UFSK_FSN_500 XLE_head-side lowering lying
surface_SN2000-4506_230427_en.docx

Safety notice

Restricted use for Treatment chairs 500 XLE with serial numbers 2000-4506

PROHIBITED - Critical patient positions!

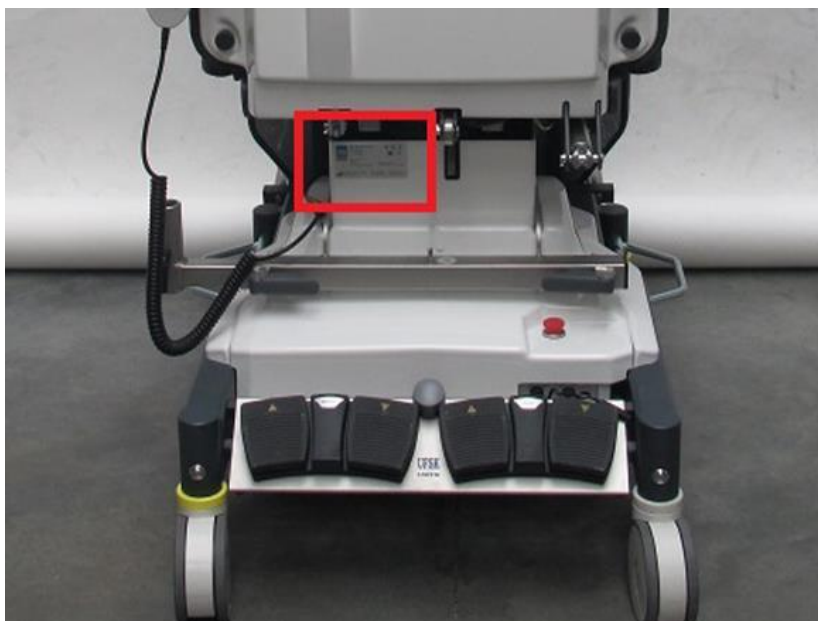
ATTENTION! The seat part must be in a horizontal position to the floor (see green cushion), the seat part drive remains in the retracted position (green marked component). Adjustment movements, e.g. into the reset position, are still possible (see adjustment positions of back and leg part shown in grey).

If the safe patient positions are not observed - in "worst case scenario" - this will cause the separation of the seat drive.

PROHIBITED! Tilting of the seat part by extending the seat part drive is prohibited. Memory positions that have been saved must be adjusted
